**Our Case Number:** ABP-316272-23

**Re:** Bus Connects Templeogue/Rathfarnham to City Centre Core Bus Corridor Scheme  
Templeogue/Rathfarnham to City Centre

**Planning Reference: REF NO ABP No 316272-23**  
**Observations in relation to TEMPLEOGUE / RATHFARNHAM TO CITY CENTRE CORE BUS CORRIDOR SCHEME – Focus Rathmines Road Lower and adjoining area**

**Location A: The location of proposed traffic light shuttle system**

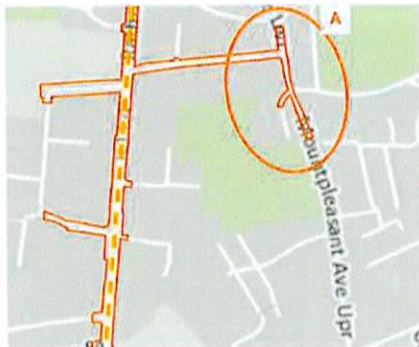
Due to the dimensions of the carriageway, the proposed shuttle system will not allow cars to pass each other at the proposed location for the shuttle system, where the width of the carriage way measures just 4.3m. We note that the proposed plans did not include any measurements of the carriage way and / or footpaths.

The pavement treatment Treatment Plan 3.06 sheet 30 for Mountpleasant Avenue Upper does not propose pavement widening to the required minimum recommended footpaths width, i.e. the proposed plan does not comply with the stated objective of the BusConnects Plan (Preliminary Design Guidance Booklet for BusConnects Core Bus Corridors) and its stated objective to be compliant with the Design Manual for Urban Roads and Streets (DMURS). The BusConnects Design Guidance references 2.0m as the desirable minimum width for a pedestrian footpath as per the DMURS, with an absolute minimum defined as 1.8m with permitted localised deviations only. According to the plans, the shuttle system traffic lights (#3 and #5) are proposed for installation on footpaths measuring <0.9m and c.1.0m wide respectively.

**Location B : Issue of cars mounting footpaths due to limited carriageway**

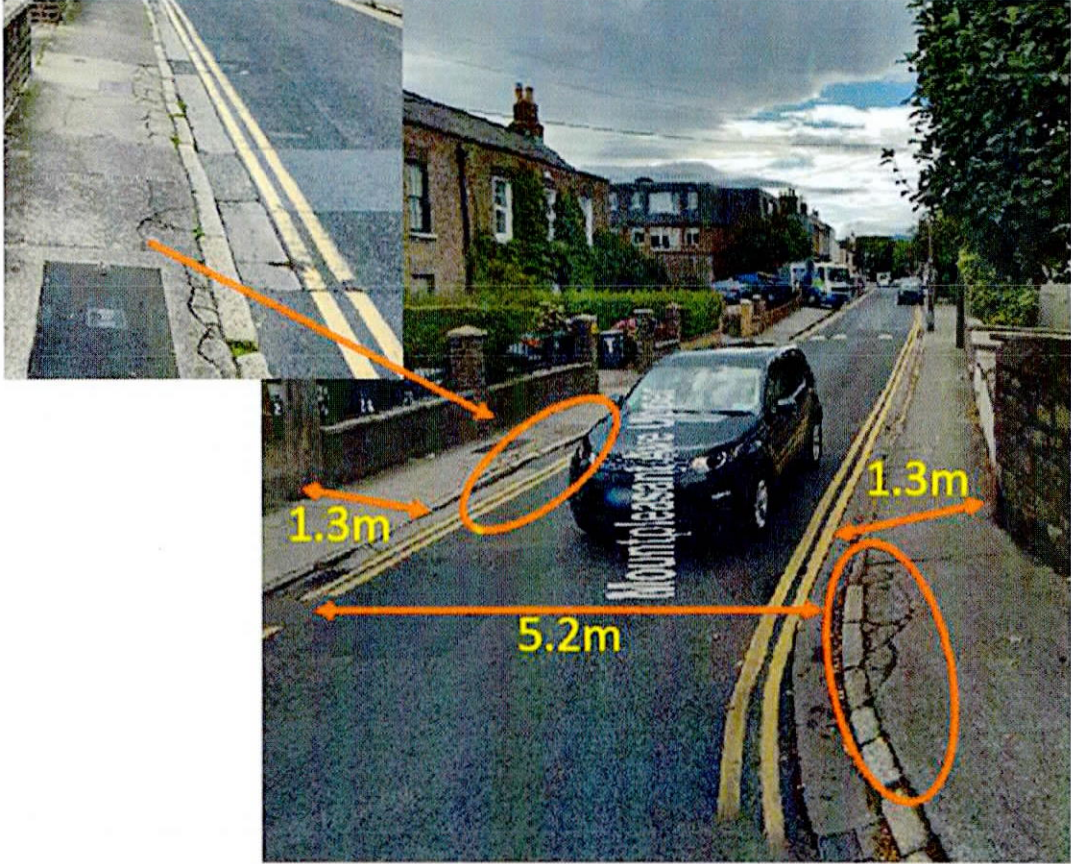
The existing no-entry for vehicles from Richmond Hill/Mountpleasant Avenue Lower into Mountpleasant Avenue was successfully implemented in 2019 following a thorough assessment by Dublin City Traffic Engineers, consultation with residents and involvement of local councillors. This measure was required as the road is too narrow in a number of sections to allow cars to pass each other without mounting footpaths.

We have included in our submission relevant measurements as well as photographic evidence showing the practice of cars driving on the footpath to pass each other prior to the implementation of the present traffic management system (no entry from Richmond Hill / Mountpleasant Avenue Lower).

**Location D: Issue of cars mounting footpaths due to limited carriageway and narrow footpaths near Belgrave Square Junction**

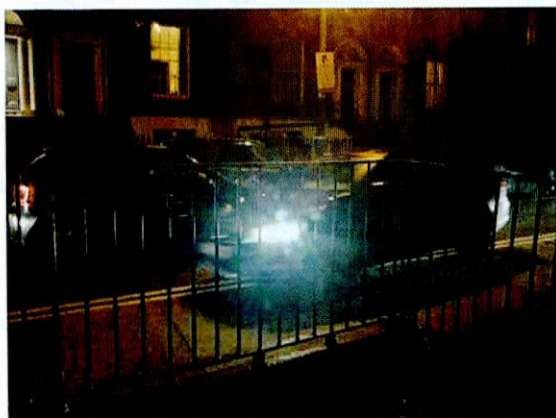
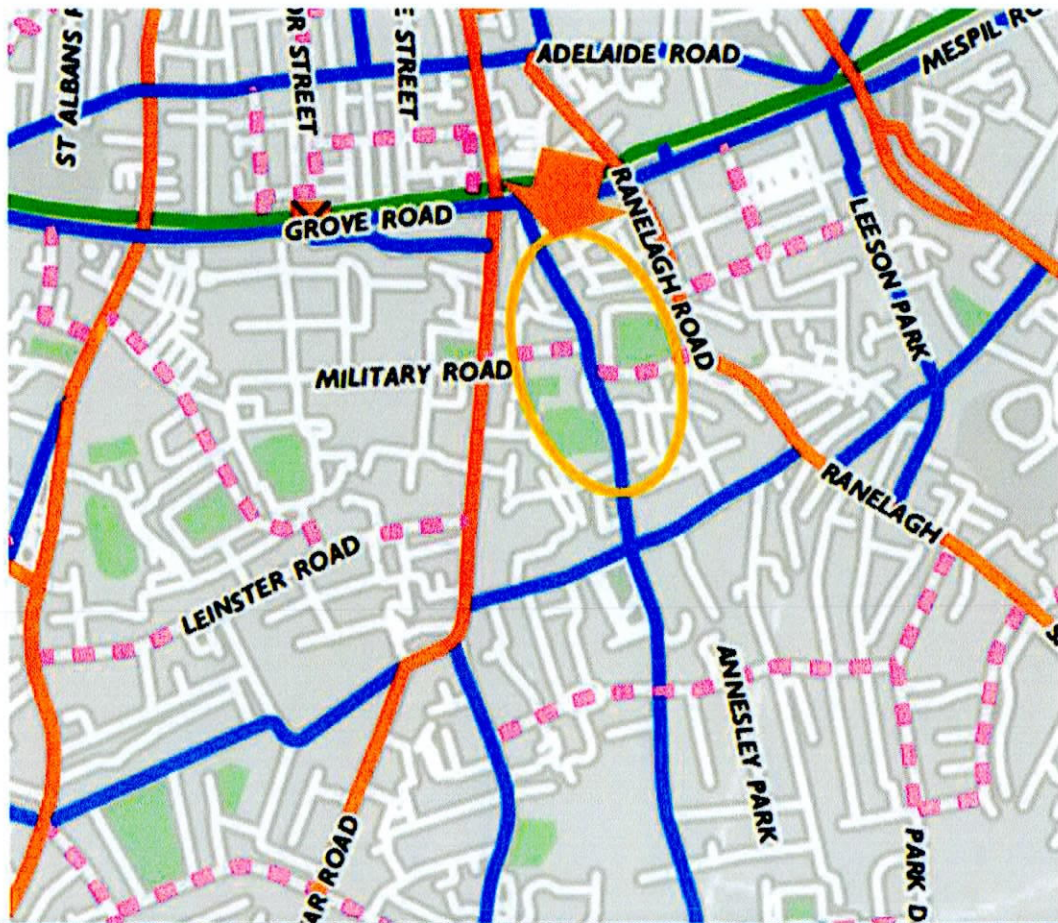
While Mountpleasant Avenue Upper has always been an important through-route for pedestrians & cyclists, the introduction of the no-entry in 2019 has resulted in a welcome further growing volumes of cyclists and pedestrians now using the road. Any increase in bi-directional traffic flow would require enhanced pedestrian safety measures to be implemented on other locations of the road where the width of footpath are substandard and non-compliant with DMURS, most notably close to the busy junction near Belgrave Square.
